# Linda Vista Gardens Replat B

City of El Paso — City Plan Commission — 2/21/2019

**SUSU17-00030 — Resubdivision Combination**

#### **Existing**

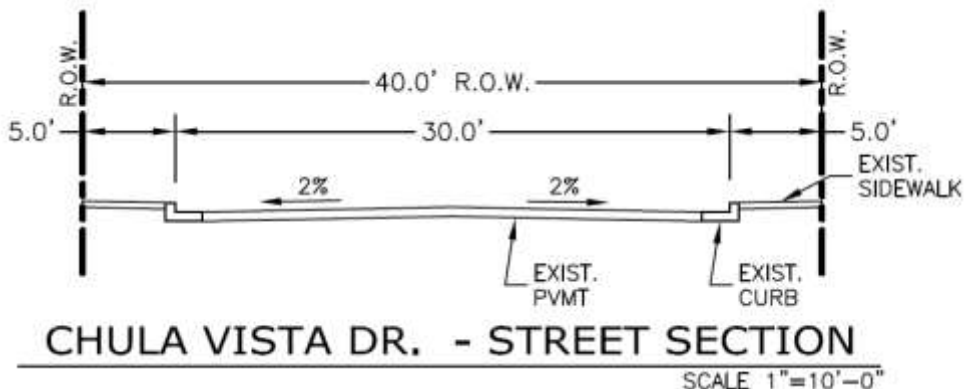
The applicant's proportionate share, per the DSC, would require installation of a 10' parkway with a 5' landscape buffer, a 5' sidewalk and 16' of pavement.

The applicant is requesting to waive his proportionate share of street improvements since 50% of lots within a quarter mile of the proposed development have already been developed and the existing street improvements are in character with the neighborhood. Currently, the sidewalk abuts the street and there are no parkways. However, the proposed exception **does meet** the following criteria under Section 19.10.050.A.1.a. (Roadway participation policies – Improvement of roads and utilities within and or abutting the subdivision) for requesting an exception as more than fifty percent of the lots within a quarter mile of the proposed development have already been developed and have the similar improvements. The section reads as follows:

## Linda Vista Gardens Replat B

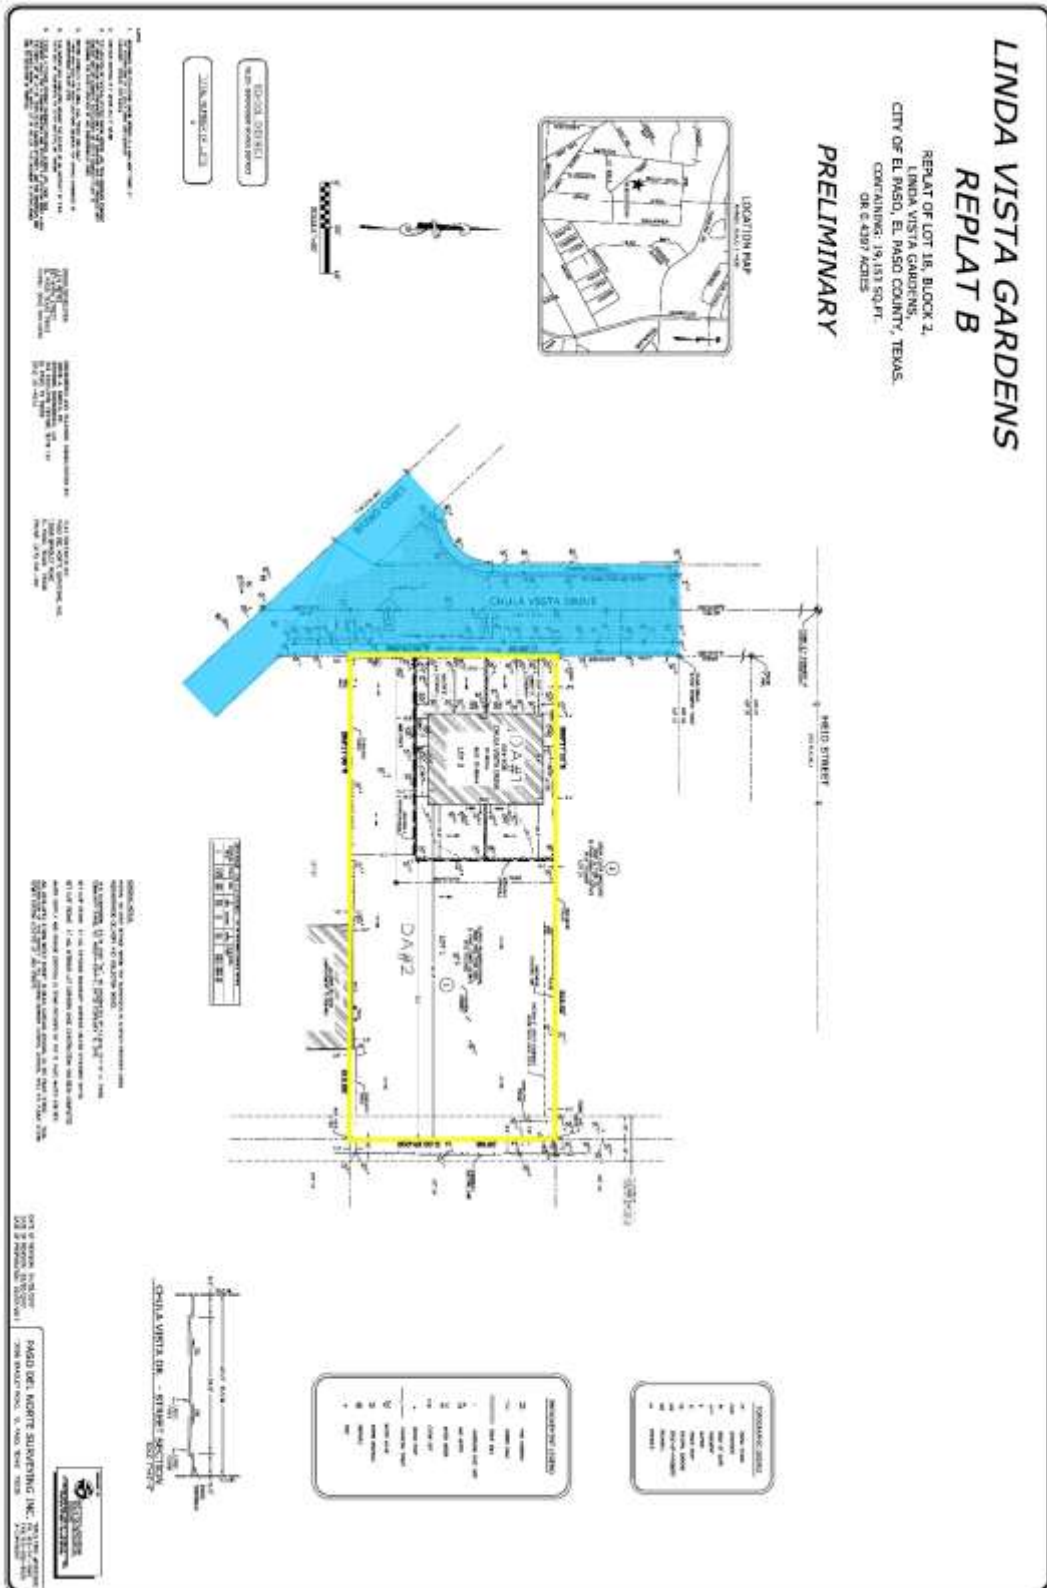
3. State reason for the replat.

4. Revise approval statement to CPC approval statement.

5. Revise Subdivision Coordinator to Chairperson.

6. Dedicate a 20' access easement.

7. Add note as to who will provide water & sewage.

- 1. At the improvement plan stage, provide protection to the subdivision from all offsite stormwater runoff that may have an adverse impact on any improvements.
- 2. To mitigate adverse downstream drainage conditions, the developer may be required to retain a portion of the developed run-off.
- 3. EPW - Stormwater Engineering recommends using principles of low impact & green infrastructure development (such as recessed landscaping, rainwater harvesting, and porous pavements) to reduce the amount of developed stormwater runoff.
- 4. There are some issues with the Mesa Drain; which shall be addressed by others.
- 5. Show storm sewer pipe running under Chula Vista Dr.

CAD requests that the lot numbers be changed as follows:

Lot 1 changed to 18A

Lot 2 changed to 18B.
